SERIAL: BSEP 09-0127

Subject: Brunswick Steam Electric Plant, Unit Nos. 1 and 2
Renewed Facility Operating License Nos. DPR-71 and DPR-62
Docket Nos. 50-325 and 50-324
Response to Request for Additional Information Regarding Request for
License Amendments to Revise Local Power Range Monitor Calibration
Frequency (TAC Nos. ME1892 and ME1893)

Response to Request for Additional Information Regarding Request for License Amendments to Revise Local Power Range Monitor Calibration Frequency

Figure 1: Signal Non-Linearity Bias

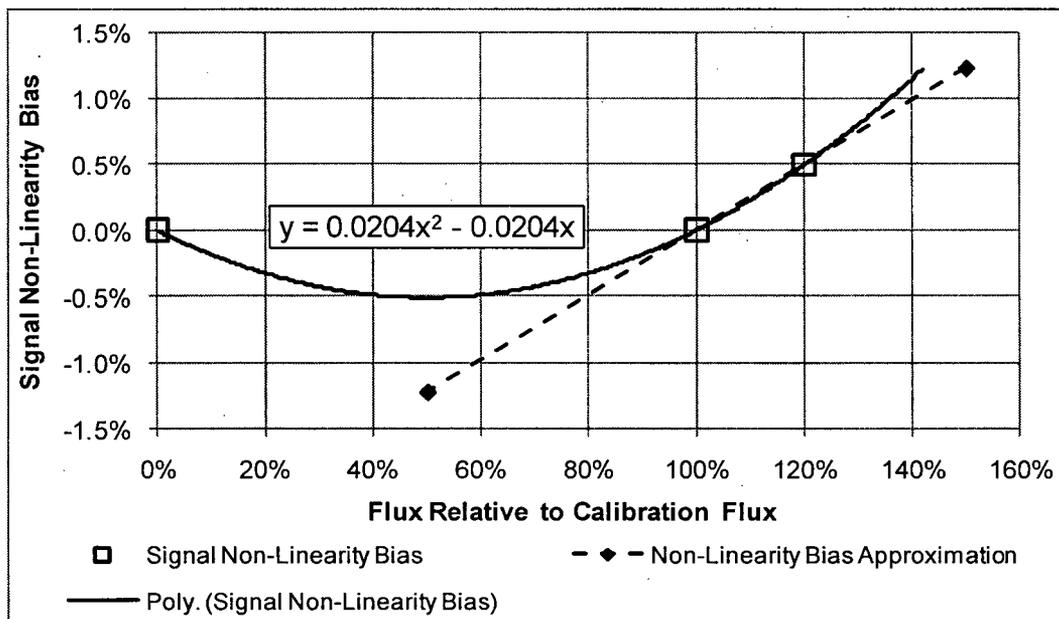
- a. Explain why the bias at the interpolated mid-point is reasonably approximated by the unconstrained bias associated with a power increase of 50%.

Approximating bias at the interpolated mid-point by the unconstrained bias associated with a power increase of 50 percent, as described in Assumption 3.2.2 of BSEP Calculation 0B21-1305 Revision 1, is reasonable in the context of the uncertainty analysis because it is conservative. The approximation is otherwise inaccurate in the context of best estimate detector bias as discussed below.

LPRM signal non-linearity bias is zero at both zero flux and at the calibration flux, and is 0.49 percent for a power increase from 100 percent to 120 percent as documented in BSEP Calculation 0B21-1305. These three bias points and the quadratic polynomial defined by the points are shown below in Figure 1.

The interpolated mid-point discussed in Assumption 3.2.2 is analogous to a reduction in power from 100 percent to 50 percent. Maximum absolute bias between zero percent and 100 percent of -0.51 percent occurs at this 50 percent mid-point based on the quadratic polynomial shown in Figure 1. Regardless of whether detector non-linearity exactly follows the quadratic polynomial, it illustrates that bias is constrained between zero percent and 100 percent because it must return to zero at zero percent and 100 percent, and that absolute bias in this range reaches a maxima at approximately 50 percent.

The uncertainty analysis linearly extrapolates 0.49 percent bias for a 20 percent power increase to 1.225 percent for a 50 percent power increase from 100 percent to 150 percent, and to -1.225 percent for a 50 percent power reduction from 100 percent to 50 percent. This extrapolation to 50 percent and 150 percent is shown by the dotted line in Figure 1. The sign of the bias is not important because the uncertainty analysis takes no credit for bias direction reducing uncertainty; therefore, subsequent discussion will ignore sign for clarity.

If power around the detector is reduced after detector calibration, the greatest detector non-linearity will be incurred for a power reduction from 100 percent to approximately 50 percent. Assumption 3.2.2 assumes this worst case by establishing detector non-linearity bias

as 1.225 percent at the 50 percent midpoint, and further based on a linear extrapolation of the known detector bias associated with a power increase from 100 percent to 120 percent, to a bias of 1.225 percent at 50 percent. This assumed detector bias of 1.225 percent at 50 percent is conservative relative to the detector bias of 0.51 percent at 50 percent projected by the quadratic polynomial.
